Office of Environmental Sustainability,  
Environmental Protection Agency,  
P.O. Box 3000,  
Johnstown Castle Estate,  
Co. Wexford

**Re: Clondrisse Pig Farm Ltd.  
Licence Application  
Ref. P0975-02**

I refer to your correspondence of 30<sup>th</sup> May 2022 and 24<sup>th</sup> May 2021 in relation to our client, Clondrisse Pig Farm Ltd. Please find detailed below the response to the issues raised.

SW – 1

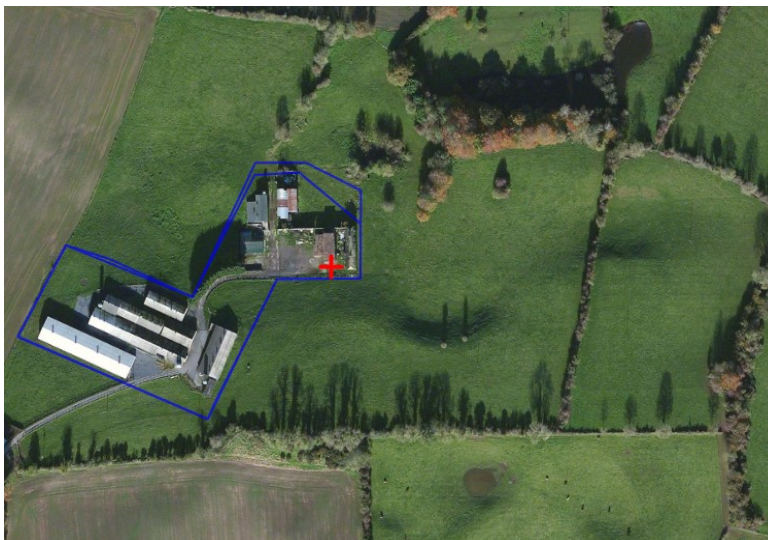
6. Confirm the grid references for the three storm water discharge points.

ING (EPSG 29902) Easting: 258704.41  
ING (EPSG 29902) Northing: 253017.48  
ITM (EPSG 2157) Easting: 658642.77  
ITM (EPSG 2157) Northing: 753040.07  
WGS84 (EPSG 4326) Longitude: -7.1156108  
WGS84 (EPSG 4326) Latitude: 53.5240495  
Web Mercator (EPSG 3857) Easting: -792106.17  
Web Mercator (EPSG 3857) Northing: 7080527.34  
New URL: <https://gis.epa.ie/EPAMaps/default?gext=258704.4,253017.5,258704.4,253017.5>  
COPY URL TO CLIPBOARD

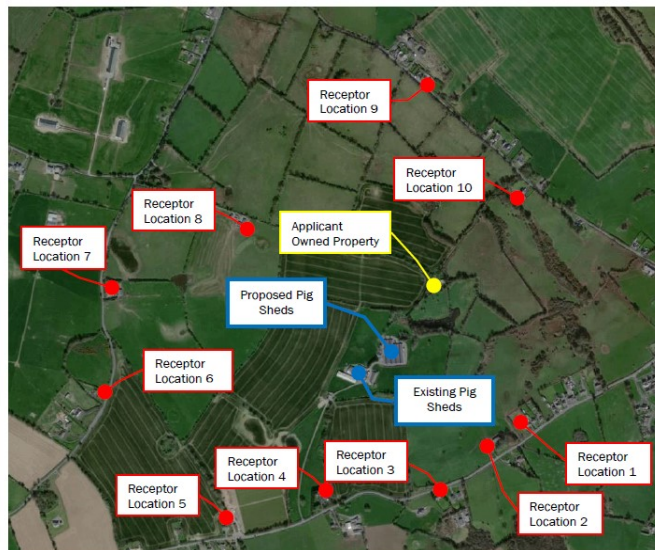
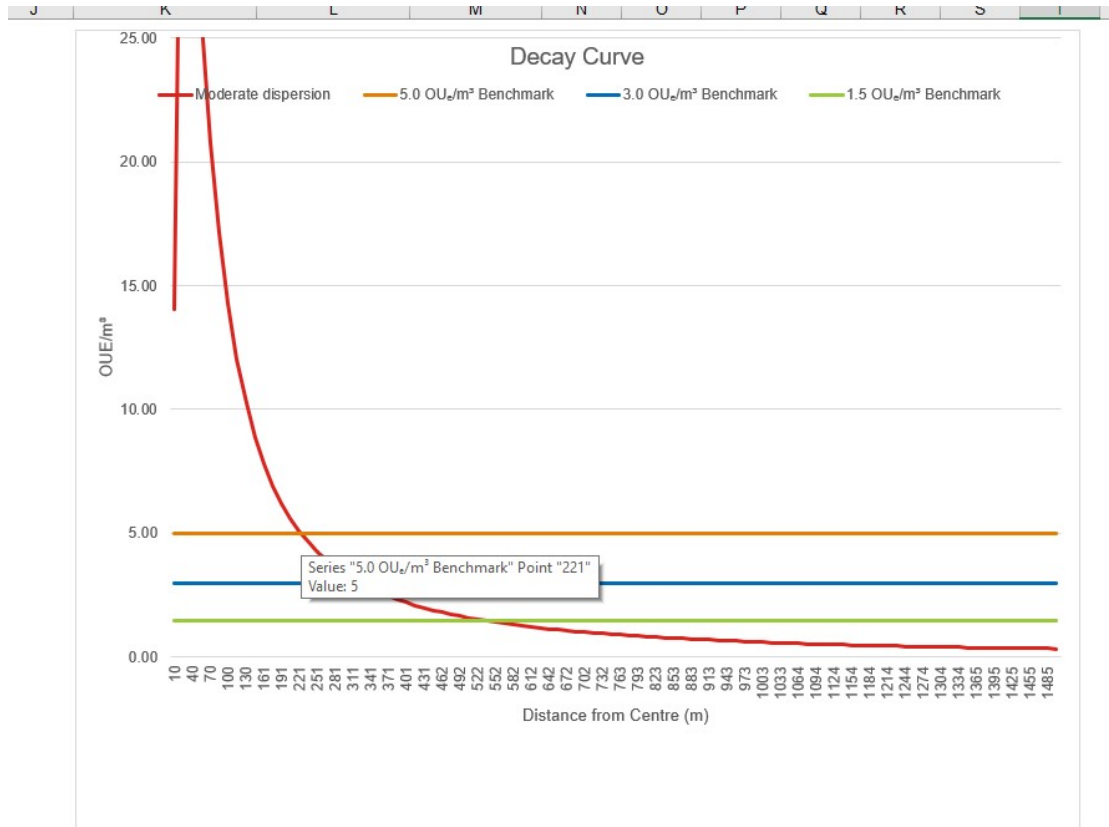
**8. Provide a revised odour assessment based on the new “EPA Pig Odour Screening Tool”.**

**Notwithstanding that this is only draft guidance and without prejudice, an odour assessment in line with the draft Agency guidance has been completed. When account is taken of the proposed mitigation measures;**

- **3% decrease in crude protein in Sow, weaner and finisher diets (30% Reduction in odour).**
- **Frequent removal of slurry from the production pig houses (25% reduction , or 12.5% if combined with low protein (42.5% combined)**

**There are no third party locations likely to be significantly adversely impacted by the existing/proposed development.**
